Historic Preservation Design Review

HP-12-06, 111 S. Main St. – Federal Building Exterior Renovations (City)

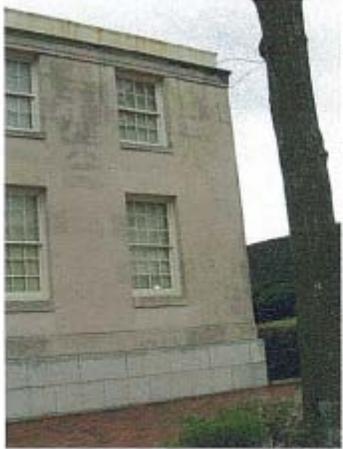
Top Left: Northwestern exterior side of the building taken from the corner of Caldwell St. & S. Main St.; Top Right: Rear of the building looking toward the intersection of Caldwell St. & N. Main St.; Bottom Left: Front facade of the building with the primary entrance; Bottom Right: The existing handicap access ramp and HVAC Units.

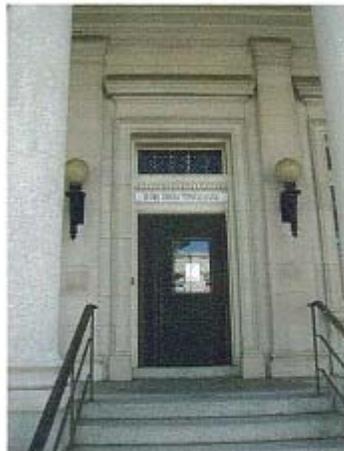
Existing interior gutters will be replaced with gutters at exterior roof edge/ wall of 2-storey portion of the building.

Wall sconces shall be added below canopy.

Existing entry door lighting will be retrofitted for emergency egress lighting.

Existing door will be replaced with door with vision panels; and guardrails will be added as required by current code.

Wall sconces shall be added below canopy.

Existing entry door lighting will be retrofitted for emergency egress lighting.

Update guardrails at handicap ramp and at retaining wall next to stairs to the basement.
